**City of Appleton
 Application for Variance**

CITY OF APPLETON MEMO

RE: Variance Application for 1405 W. Wisconsin Ave. (31-1-1043-00)

ATTENTION: MARK DOUGHERTY
 1405 E. WISCONSIN AVE.
 APPLETON, WISCONSIN, 54911
PROJECT: PARKING EXPANSION

"SITE PLAN" E. WISCONSIN AVE. (66')

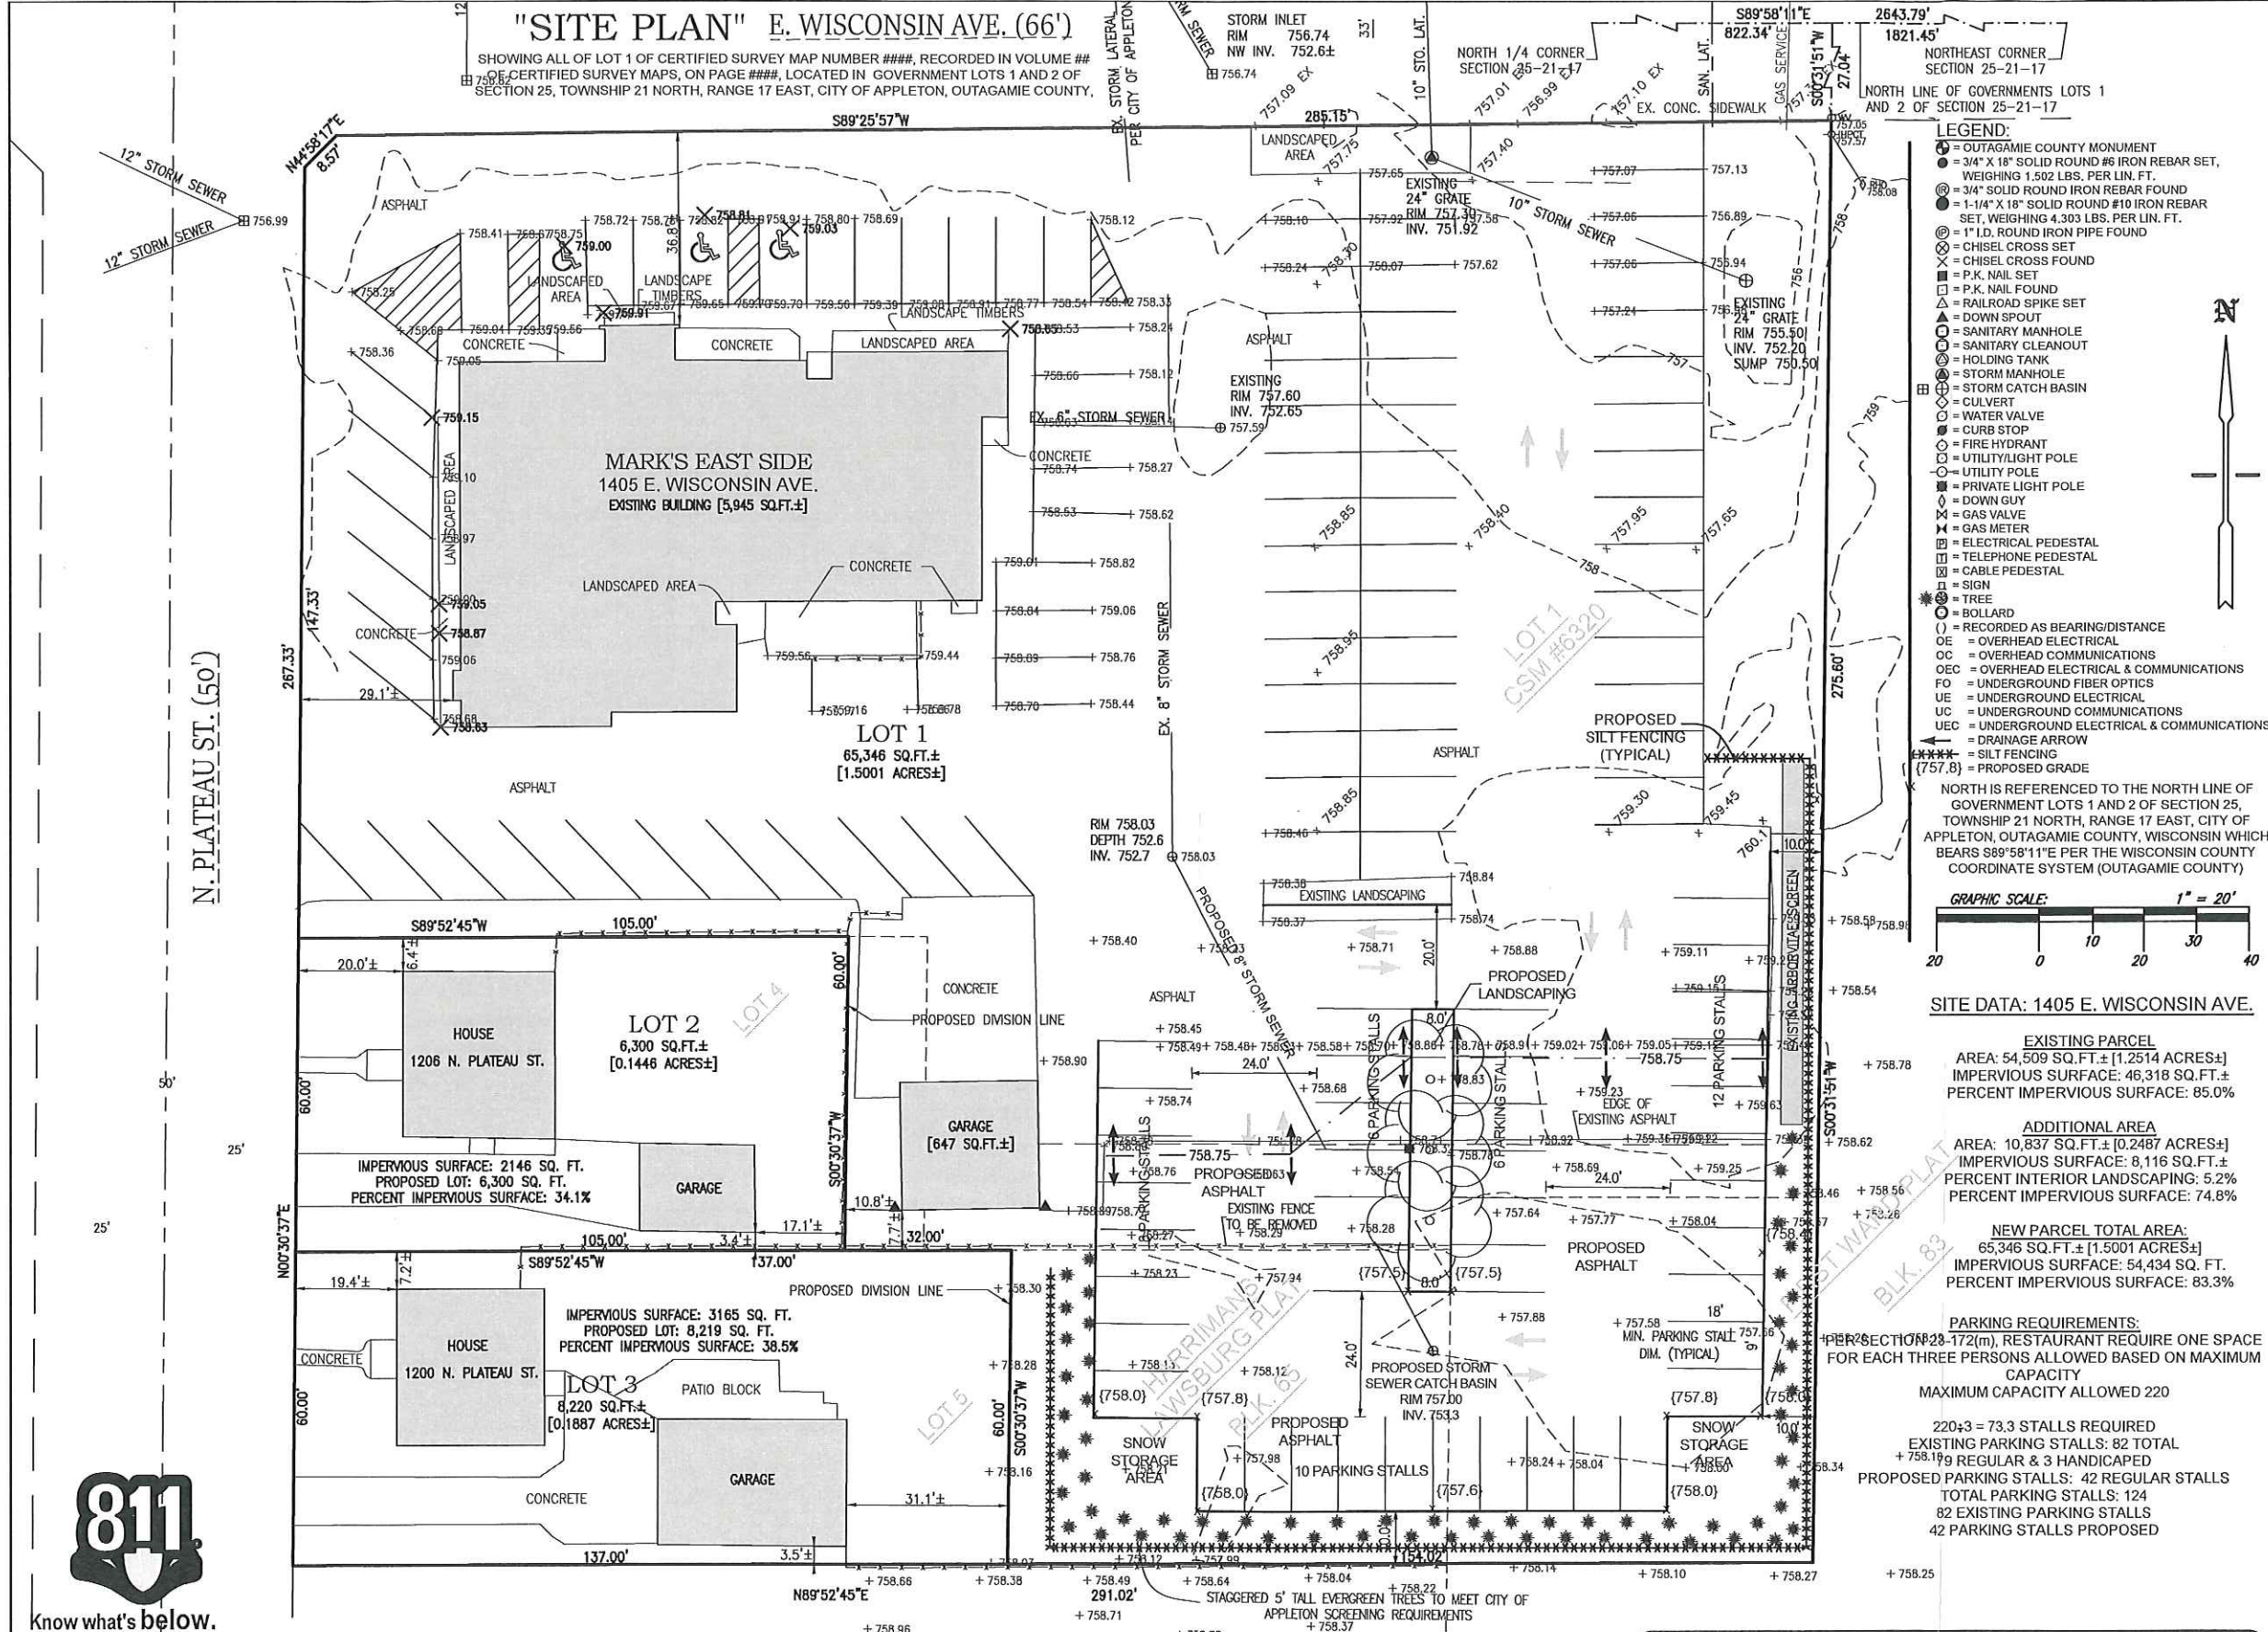
The applicant is proposing to expand an existing parking lot. The proposed lot coverage is 83.37%. Section 23-172(h)(2) of the Zoning Ordinance requires a minimum lot coverage of 75%. The proposed percentage of landscape islands is 2.6%. Section 23-172(f)(1)(a) of the Zoning Ordinance requires 5% of the lot to be landscape islands.

This property is 54,509 sq. ft. The minimum size lot in the C2 zoning district is 14,000 sq. ft.

The Board granted a variance for no landscape buffering and 85% lot coverage for this property on 8/15/11.

With the proposed expansion of the parking lot, the lot coverage would be 83.37%, which is less than what was previously approved. The reason for the variance in 2011 was because there was no practical application for the existing area to require extra green space.

The proposed parking lot meets the zoning standard for minimum required parking spaces. However, historically, street parking for this business is needed to accommodate patrons on Friday and Saturday nights.
